PHAP14-00023

Date: September 8, 2014
Application Type: Certificate of Appropriateness
Property Owner: Martin Building LLC
Representative: Martin Building LLC
Legal Description: Being 5 Mills 20 ft. on Mills X 80 ft. Beg. 95 ft. W. of NEC (1600 sq. ft.)
City of El Paso, El Paso County, Texas
Historic District: Downtown
Location: 114-A Mills Avenue
Representative District: #8
Existing Zoning: C-5/H (Commercial/Historic)
Year Built: 1948
Historic Status: Landmark
Request: Certificate of Appropriateness for the rehabilitation of the property including a new storefront, signage, lighting, railings, and modification of a window into a door.
Application Filed: 8/18/2014
45 Day Expiration: 10/2/2014

ITEM #2

Certificate of Appropriateness for the rehabilitation of the property including a new storefront, signage, lighting, railings, and modification of a window into a door.

PROPOSED ELEVATION

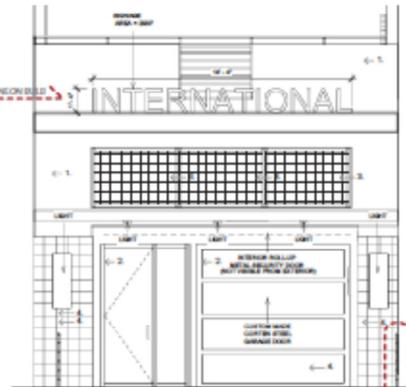
The modifications are that the new storefront be made of a metal other than Corten steel; that the existing glass in the transom windows be restored rather than replaced; and that the entry door and roll-down garage door be configured to look like a historic storefront.
